Department of Transport and Planning

DEPARTMENT OF TRANSPORT AND PLANNING RESPONSE TO PUBLIC EXHIBITION- CROSKELL (EMPLOYMENT) PRECINCT STRUCTURE PLAN, INFRASTRUCTURE CONTRIBUTION PLAN AND CASEY PLANNING SCHEME AMMENDMENT C296CASE

Attachment A – Movement Network Comments

Figure 1. Movement Network and Public Transport Comments

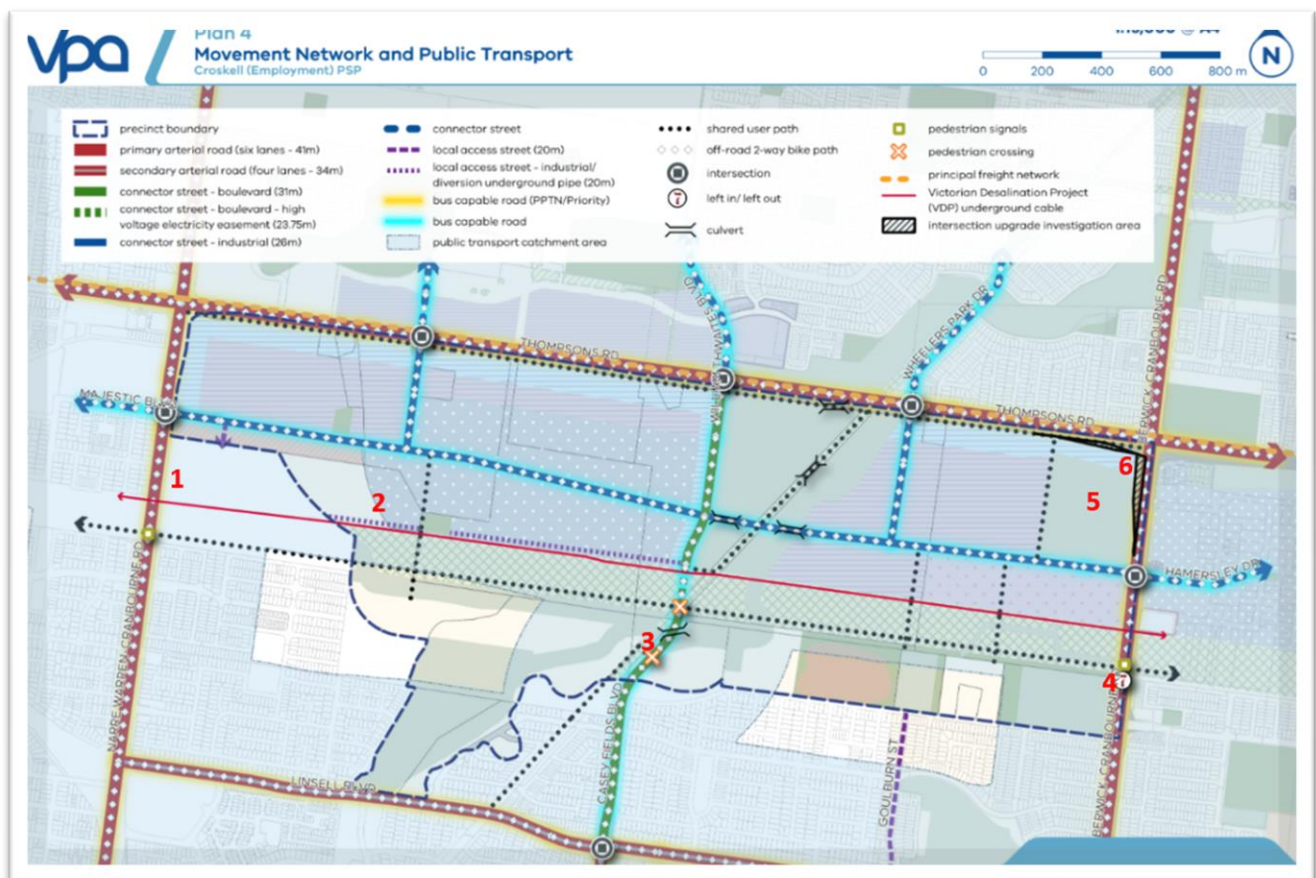
1. The proposed pedestrian crossing as included in the Appendix to the ICP does not connect to the existing footpath located on the western side of Narre-Warren Road. The ICP plans should be revised showing a connection into the existing footpath shown below within Figure 2.

2. There is a local industrial access street connection shown within the residential area. It does not connect into any existing / proposed road networks shown within the plan or within the adjoining area. Please provide further clarification on its location and alignment in relation to the surrounding land uses, including the gap shown within the open space.

3. It appears that there is a gap between the pedestrian crossing and the shared user path that it connects to the south of the easement area.
4. Address matters relating to the feasibility for the provision of a left in left out (LILO) access to the open space adjacent to Berwick- Cranbourne Road.

5. Ensure that any amendments to the location of the retarding basin are referred to the Department for consideration, given its interface with the declared road network and current Big Build Project - Thompsons Road and Berwick-Cranbourne Road Intersection Upgrade.

6. That the PSP boundary be updated to reflect the above big build project, removing the 'investigation area' as this land has since been acquired by the project.
